AGENDA

ARCHITECTURAL REVIEW BOARD MEETING

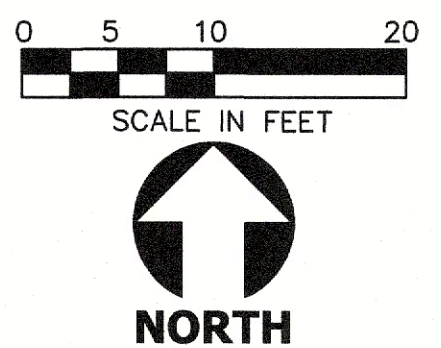
- Landscape plan is subject to change with engineering plan review.
